YEAR/MODEL ANNEE/MODELE	DATE OF ISSUE DATE EN VIGUEUR	BULLETIN NUMBER NUMERO DU BULLETIN
1993 del-SOL	APR. 15 / 1994	IX - 1 - 94

PRODUCT UPDATE: 1993 del-SOL REAR WINDSHIELD SEAL

WEATHERSTRIP
 Detach the clips while prying the weatherstrip rearward by hand, then remove the molding.

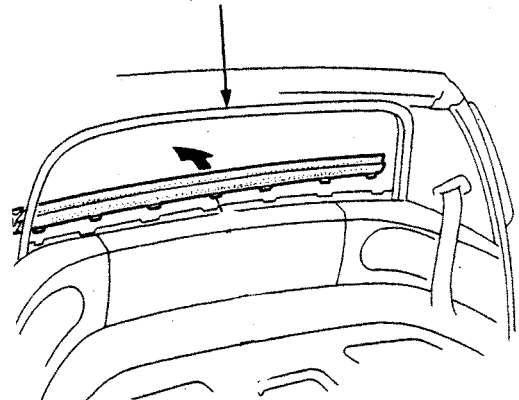
3. Lower the rear windshield.
4. Remove the outside bottom weatherstrip.

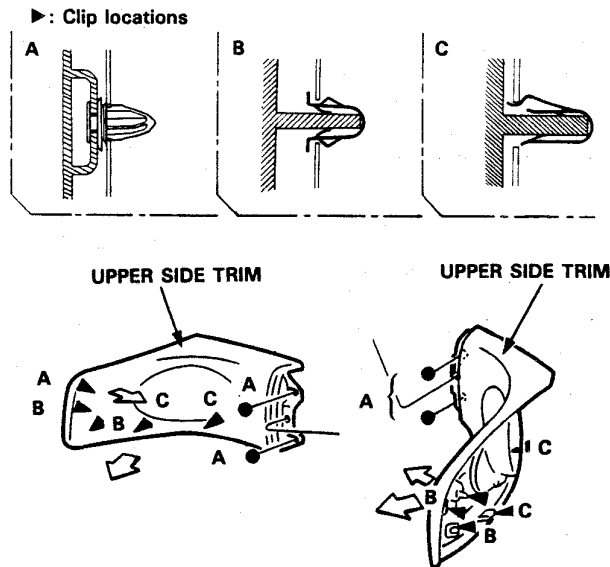
5. Move both seats forward and tilt the seat backs forward.

6. Remove the upper side trim panels.

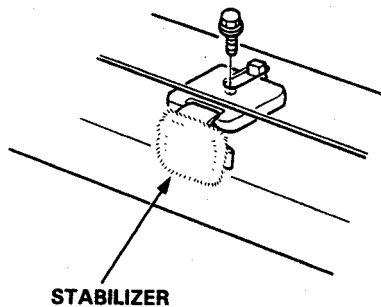
7. Close the rear windshield.

8. Remove the rear windshield glass stabilizers.

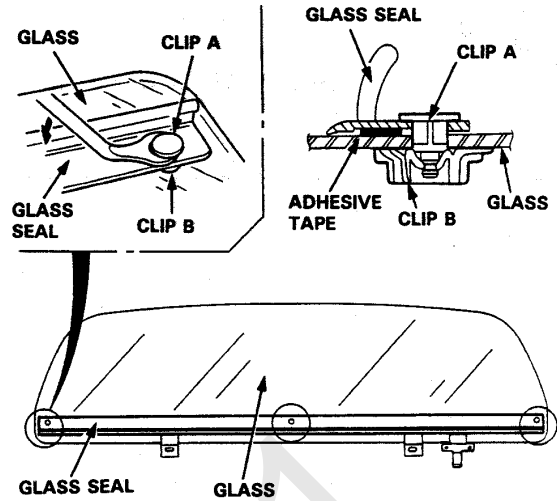
10. Remove and discard the (3) clips holding the bottom seal.

1. Have an assistant hold clip "B" with a pair of needle-nose pliers.

1. Use the trim panel removal tool to remove clip "A" from clip "B". Do not let the clip parts fall in the windshield cavity; they may rattle or clog up the drains. Should any of the clips accidentally fall into the cavity, pick them up with a flexible mechanics claw, or a straightened coat hanger with sticky putty on one end.

11. Carefully remove and discard the bottom seal from the windshield. Be careful not to scratch any part of the heating element on the glass.
